ORDERS UNDER SECTION 96 (2) OF ACT III OF 1901.

With reference to his application dated 21st August 1909 :
 Mr. Abdullah Hussain is informed
 that the plan submitted by him for building a house
 on plot No. 74 Survey Sheet A 2
 situate in V. Lungee Shop Street, old line
 Quarter, is approved, and permission to build in accordance therewith is
 granted. The building to be erected subject to the Byelaws and Rules of the
 Municipality.

OLD TOWN Q⁵.Sheet N^o. A, 2

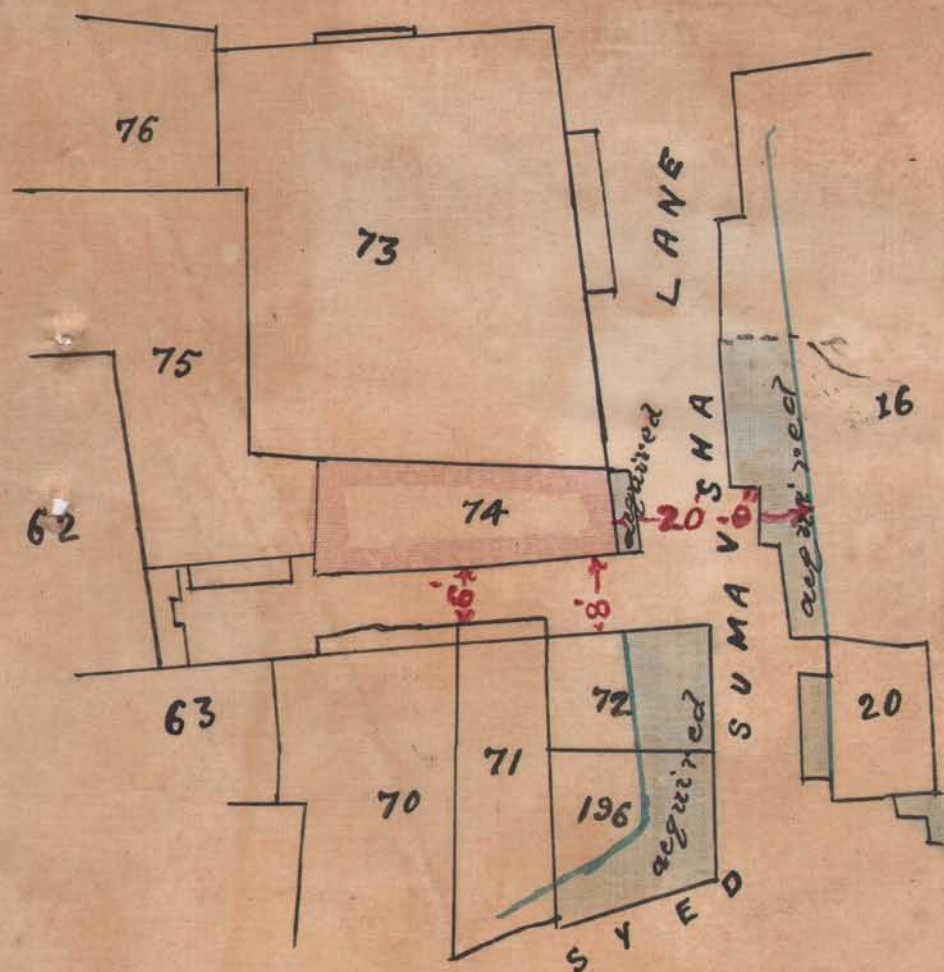
A detailed plan of the upper floor must be submitted and the ground floor plan must be amended. The privy must be shown to be constructed in accordance with the Bye-laws, the drain must not be carried into the stable. In the opinion of Undersigned the situation is not suitable for a stable as it causes many other difficulties to arise in disposing a building on the plot .

With reference to his
application dated the 18th August
last with a plan of a stable
to be built on plot No 74 A 2
old town gr. Mr. Motam al
Naroomal is informed that
the plan submitted is disapproved as
a stable cannot be permitted under
living rooms.

*Plan disapproved.**A stable cannot be permitted under living
rooms.*

With reference to this
 Ilegio report that the
 applicant has altered the
 plan & now there is no
 objection in granting pass.

With reference to your letter no L 4056 of 16th inst. we beg to state that the ~~plan~~ only one Hall built on the upper floor of plot no 74-02 old town or is not meant for living purpose so long there is stable on the ground floor. The upper hall will only be used for the storage of Carriage & horse materials and other dead stocks.
